ADDENDUM NO. Three (3)
PROJECT NO: 112741
TITLE OF PROJECT: Headquarters HQ Replacement Phase 1
FACILITY LOCATION: Tyler State Park, Smith County, Texas

ADDENDUM NO. 3

Tyler State Park
Headquarters
TPWD Project Number 112741
FPC Project Number 92705
October 8, 2020

1 ENLARGED FLOOR PLAN - AREA A

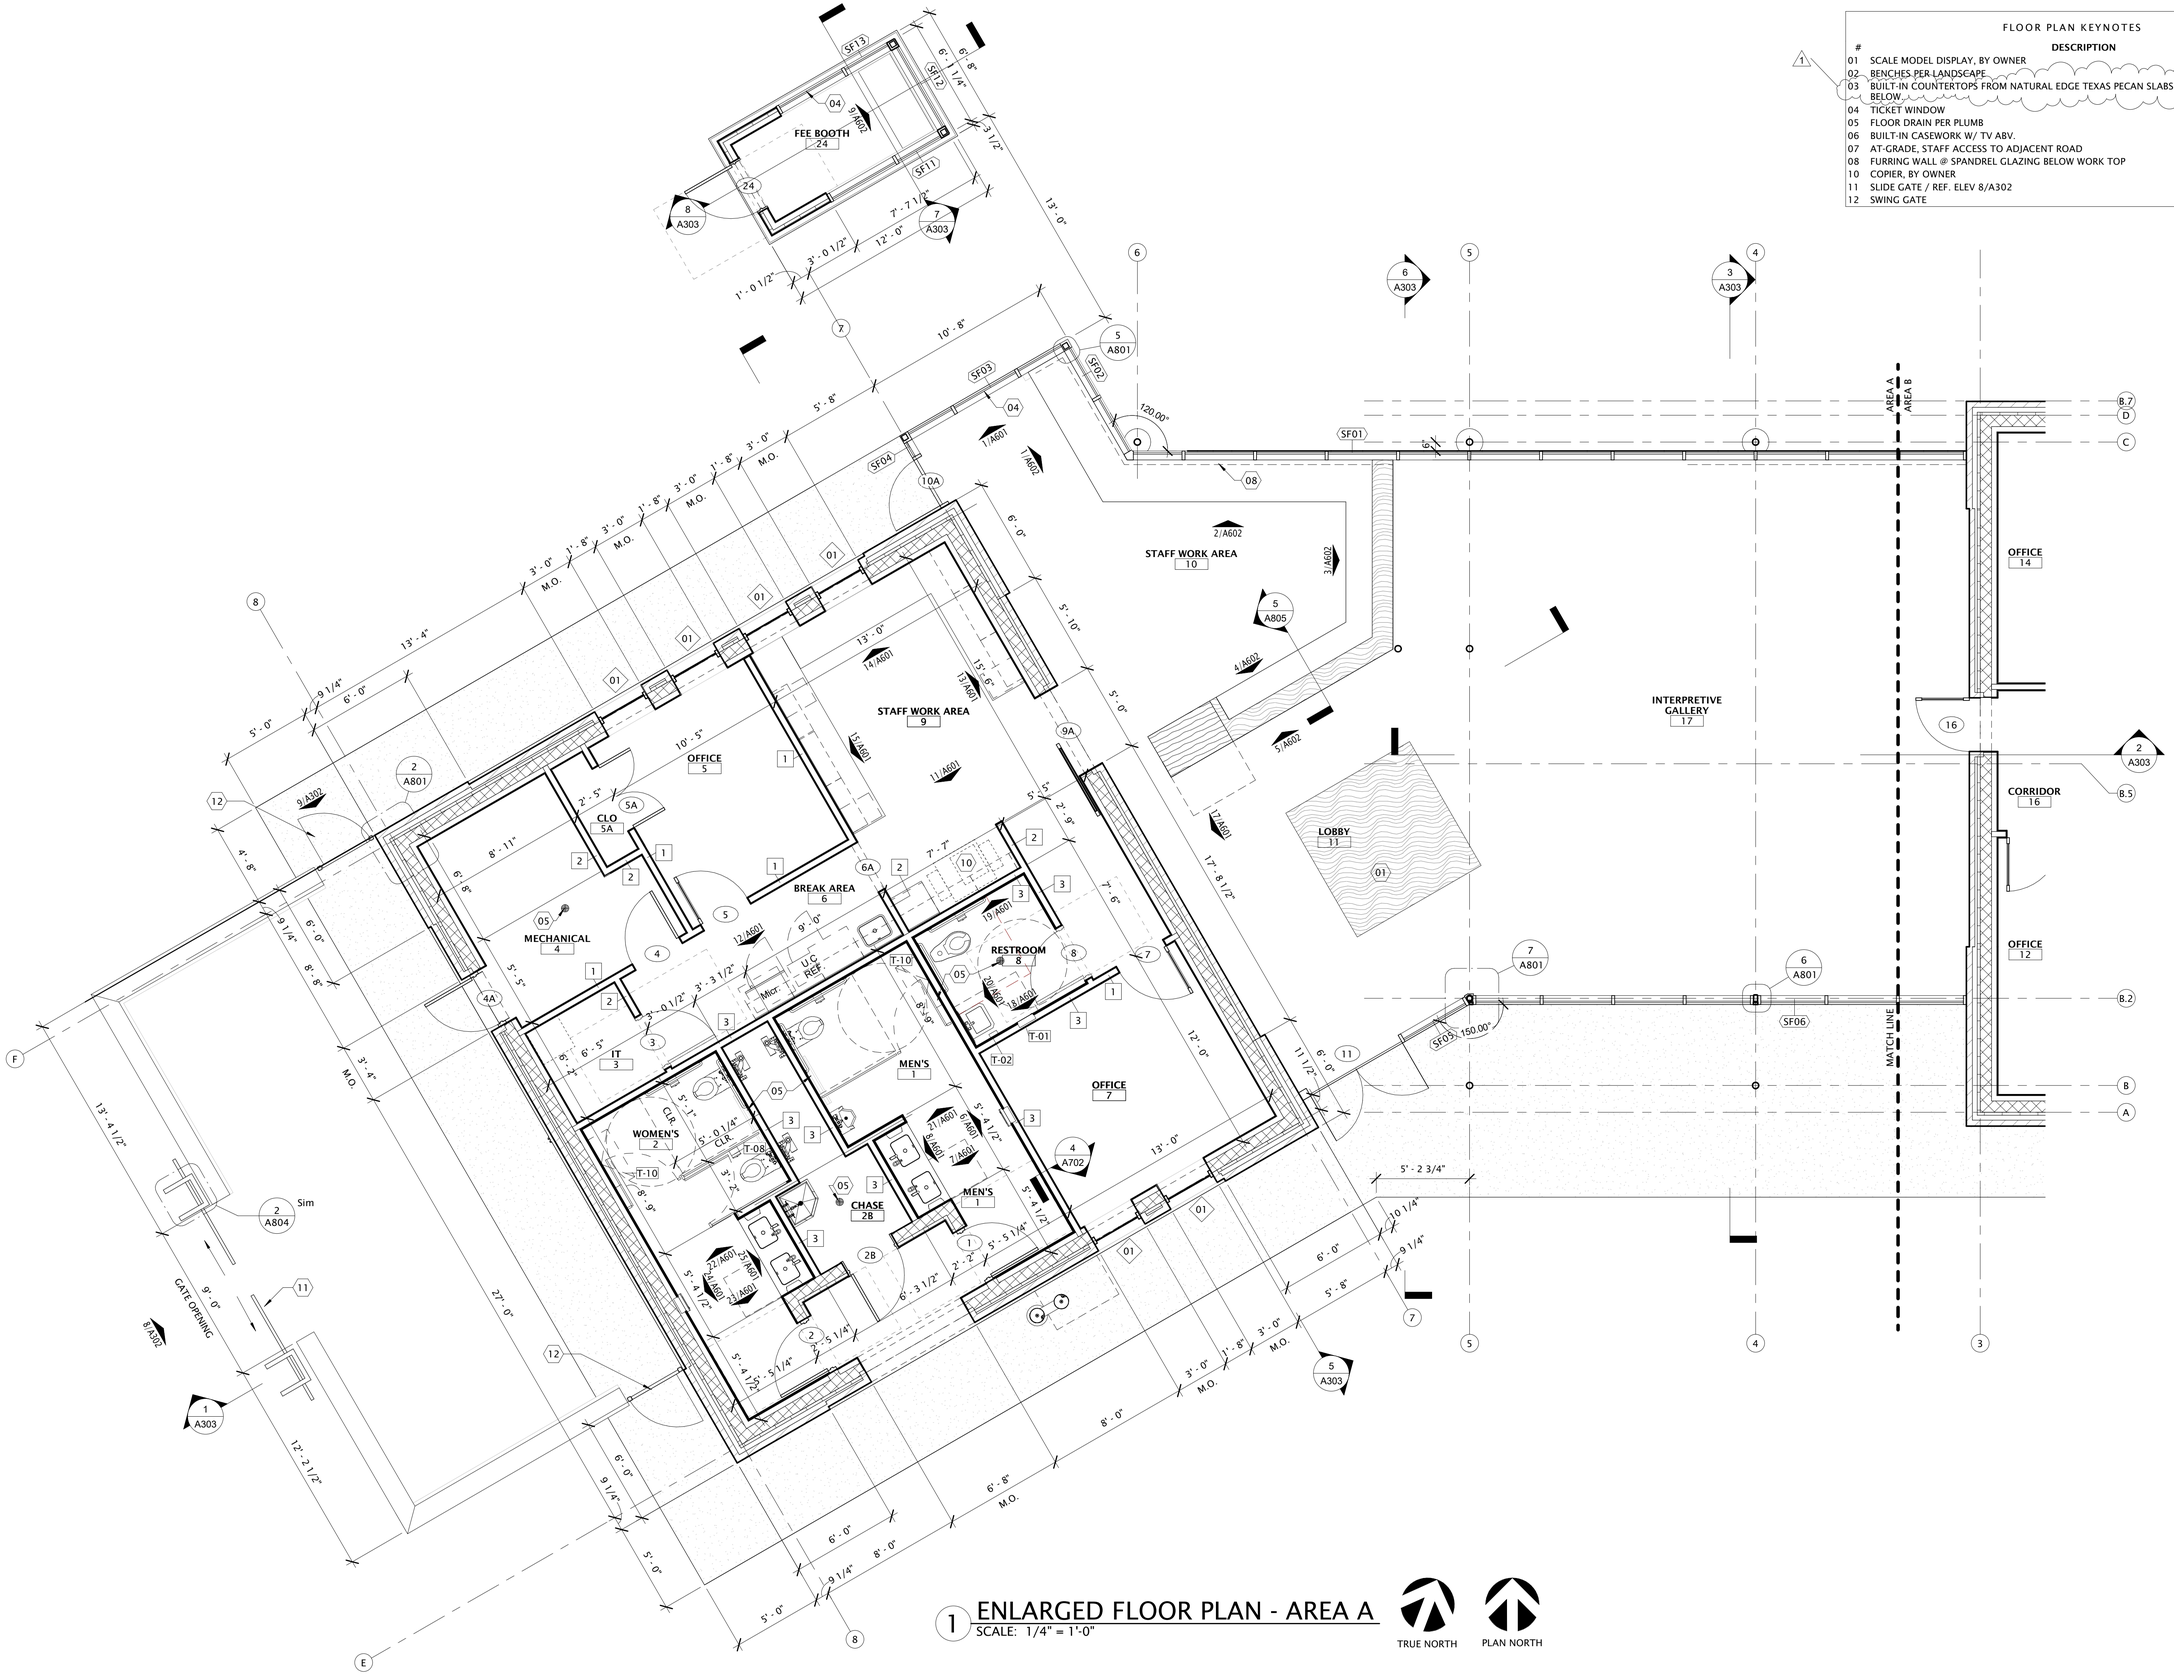
Item 3.05 Sheet A202 Enlarged Floor Plan Area A (One 24 x 26 sheet)
Revise floor plan key notes.

21 ALUM WINDOW SYSTEM SF05
1/4" = 1'-0"

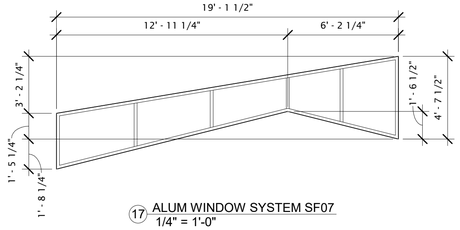
Item 3.06 Sheet A602 Interior / Storefront Elevations (One 24 x 26 sheet)
Add curtain wall note to window type SF05.

Q16. Two types of aluminum framing systems are spec'd and the drawing details do not show a distinction between the two. Please indicate which aluminum window frames are intended to be furnished as curtain wall.

A16. Curtain wall window note added to window type SF05 on sheet A602 in addendum 03.

4 WINDOW HEAD @ STONE WALL
1 1/2" = 1'-0"

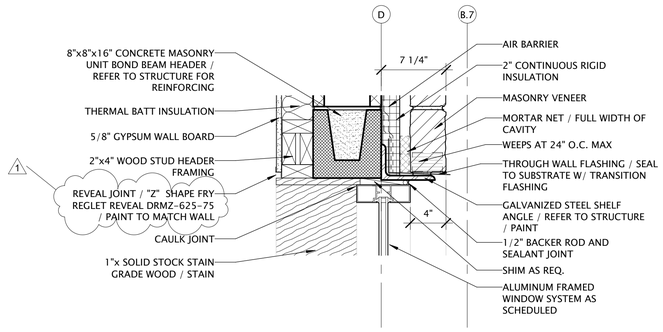
Item 3.07 Sheet A803 Section Details (One 24 x 26 sheet)
Revise detail note.

A7. Reveal joint to be provided around wood trim at openings as shown in detail 4/A803. Detail has been updated in addendum 03 to call out Fry Reglet reveal type. Detail 1/A803 is showing wall to roof detail, no reveal joint at this location

1 FIRST FLOOR FRAMING PLAN - AREA A

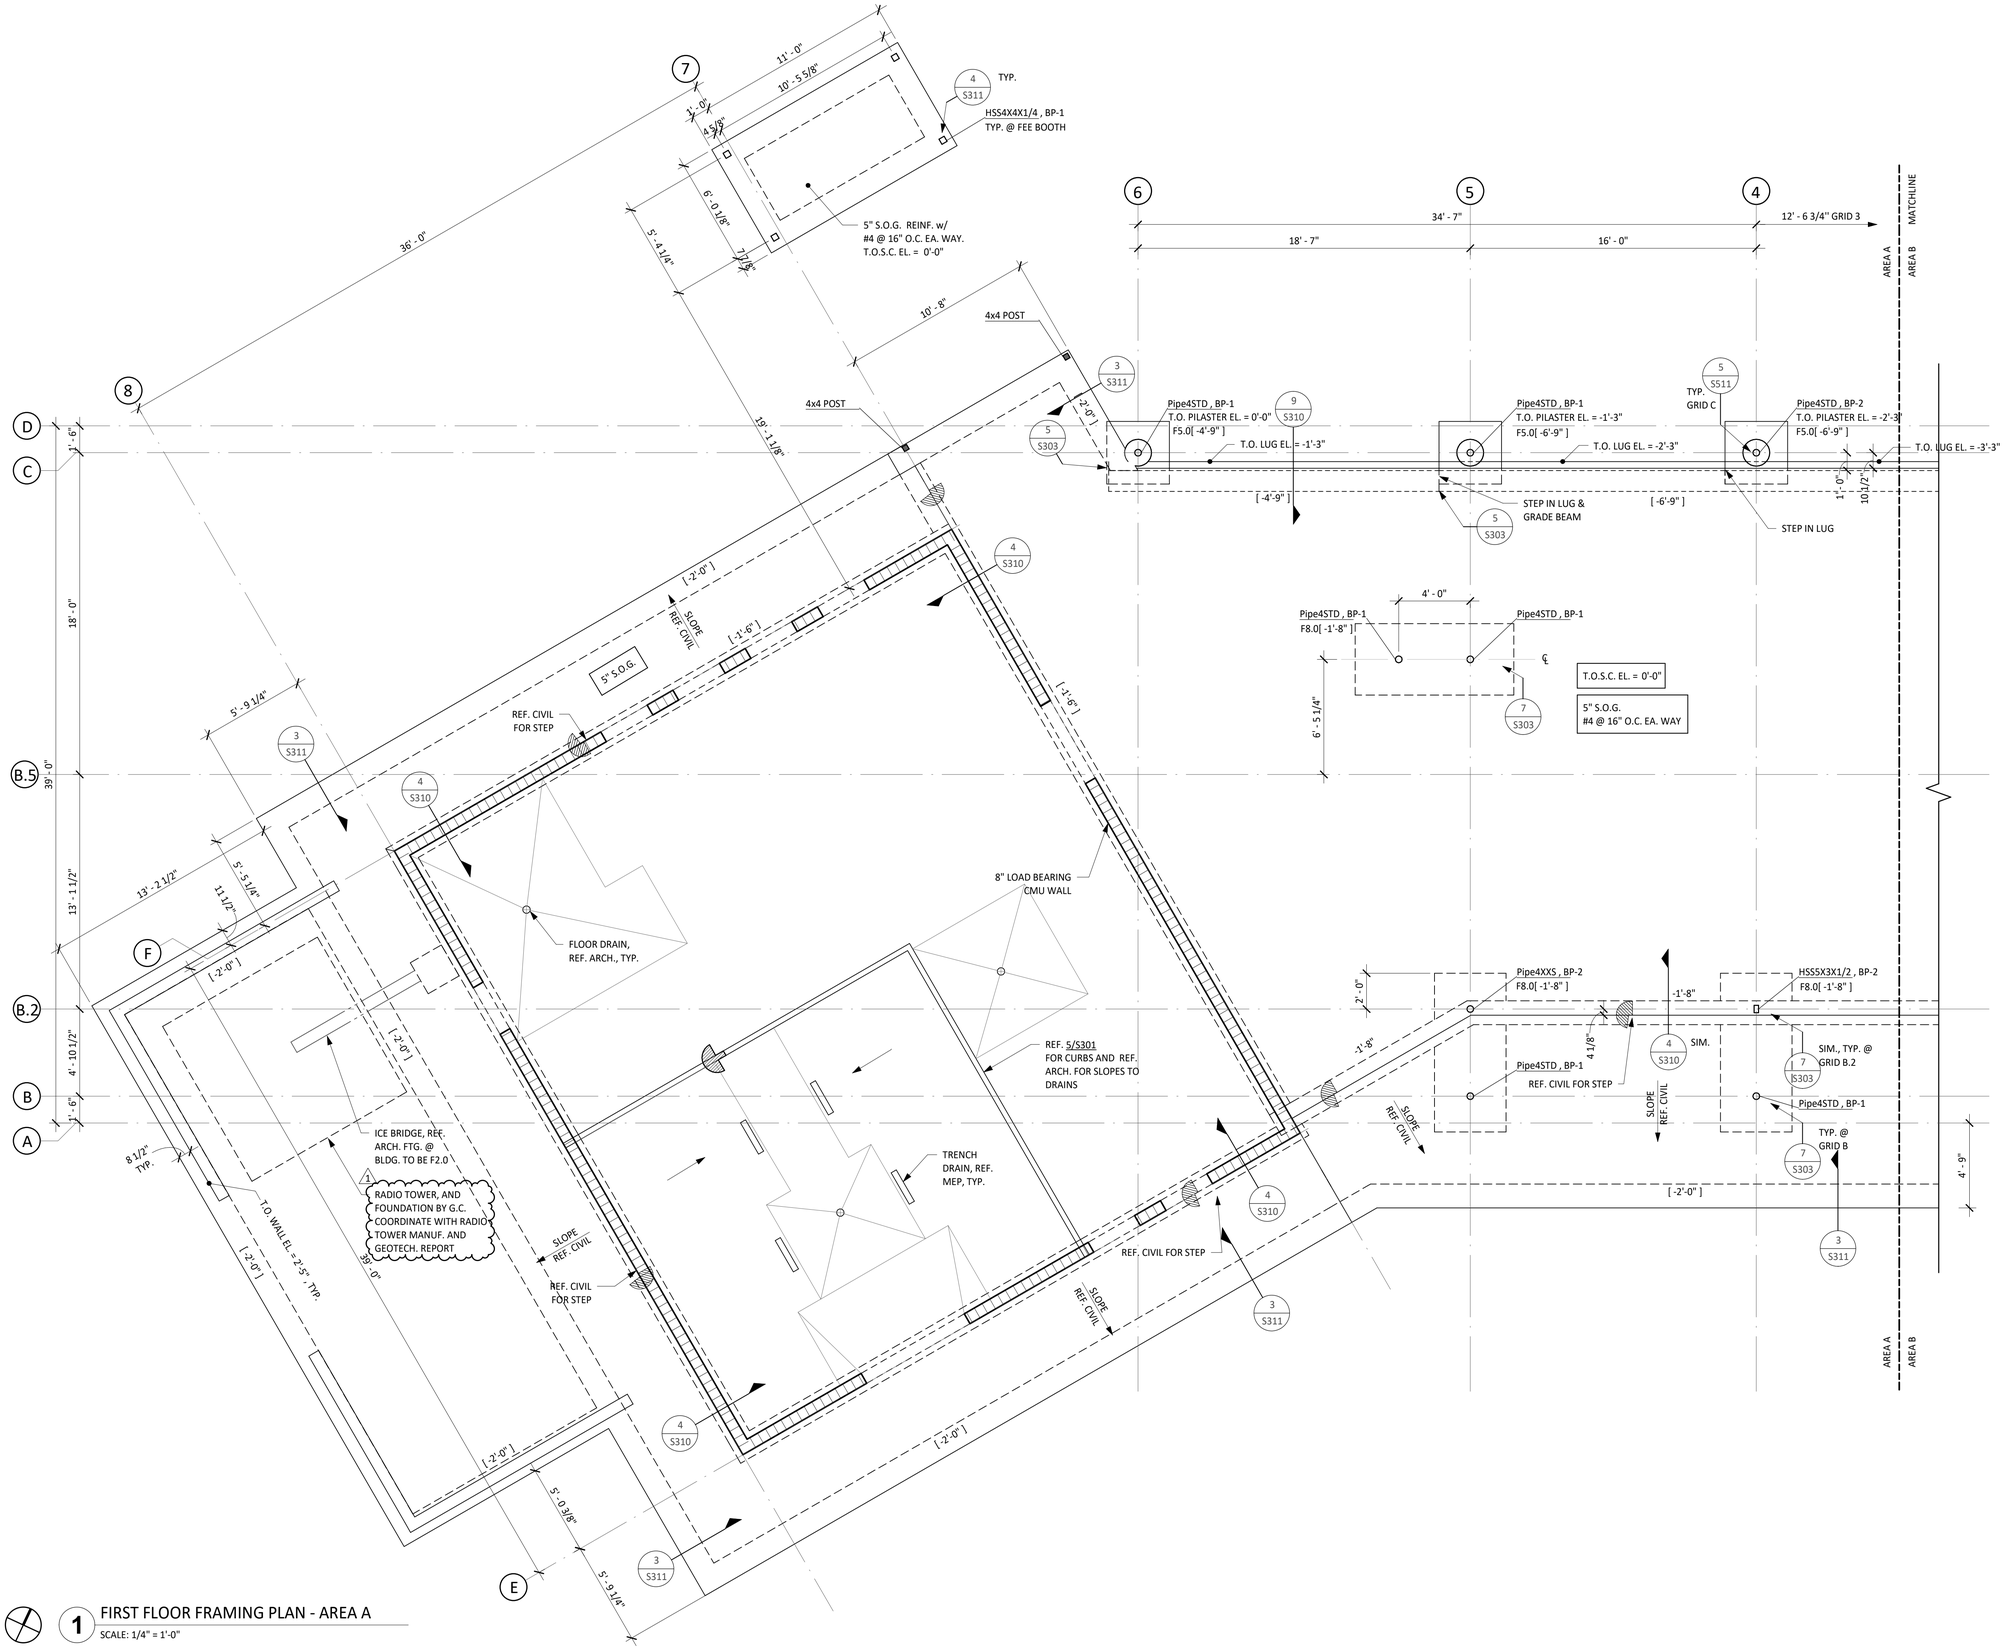
Item 3.09 Sheet S202 Floor Plan Framing Plan – Area A (One 24 x 26 sheet)
Revise radio tower note

5 SECTION - UNDERGROUND TANK FOUNDATION
SCALE: 1" = 1'-0"

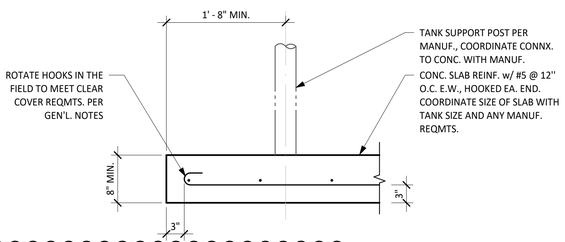
Item 3.10 Sheet S311 Concrete Details (One 24 x 26 sheet)
Add detail 5 to sheet for propane tank foundation.

Q5. Propane tank-To be owner/owner vendor provided correct? What is size of pad?

A5. Propane tank is to be provided by contractor, final size of pad to be coordinated with tank selection. Detail for pad provided by structure in addendum 03.

1 MECHANICAL FLOOR PLAN - 1ST FLOOR

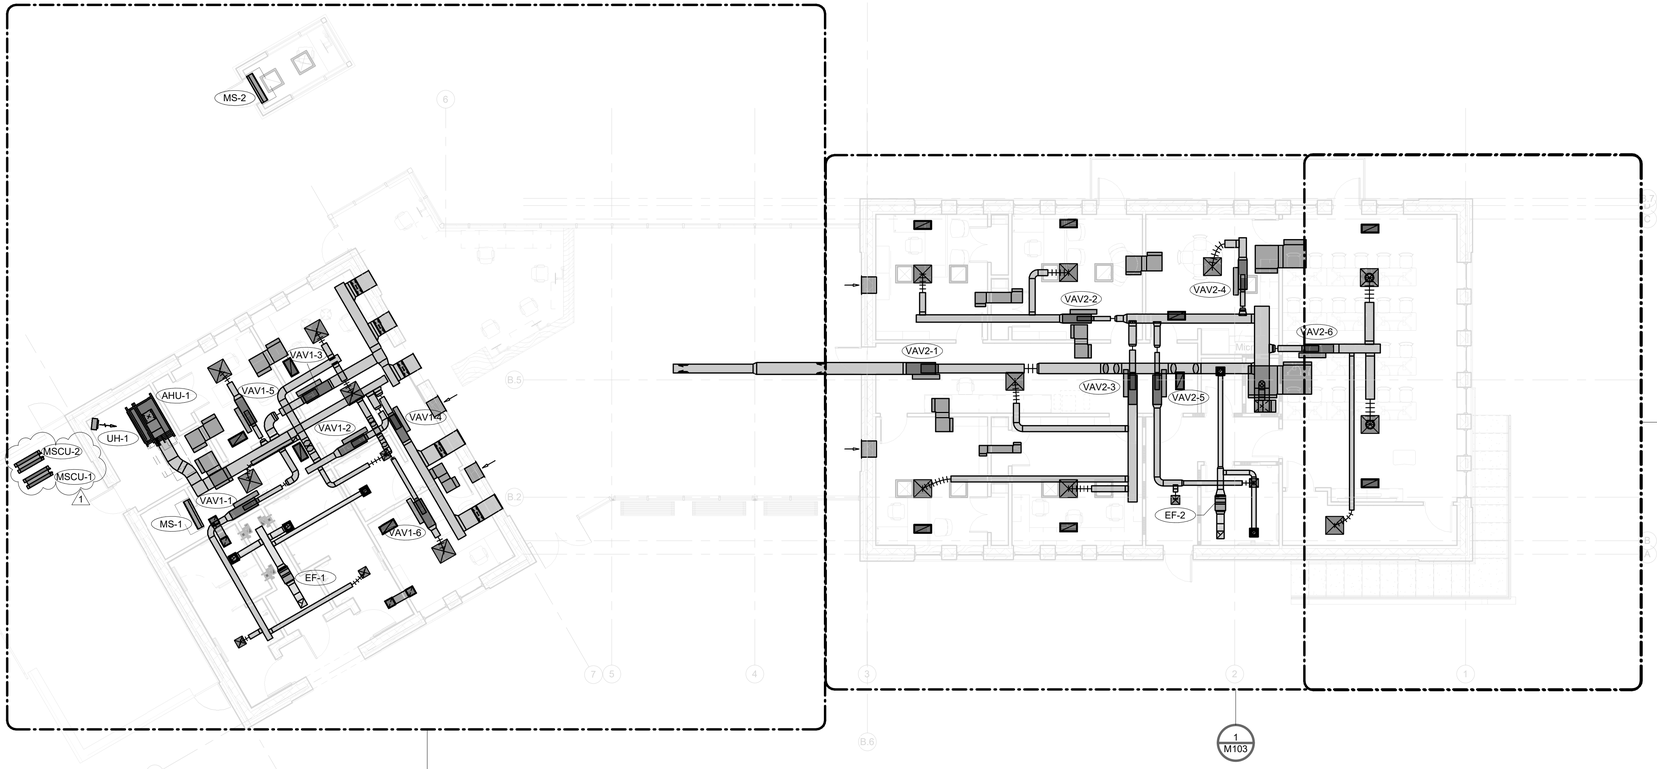
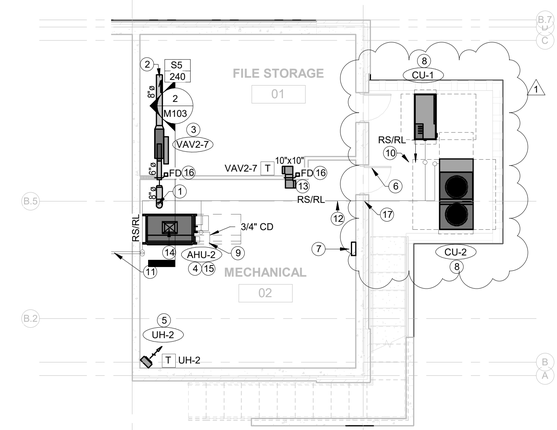
RE: Plan Sheet M101:
- Item 1: Relocated MSCU-1 from Mechanical Yard on Eastern side of building to yard on Western side of building.
- Item 2: Revised Refrigerant line set routing as a result of Item 1.
- Item 3: Revised rating of fire damper.
- Item 4: Revised keyed note #6.
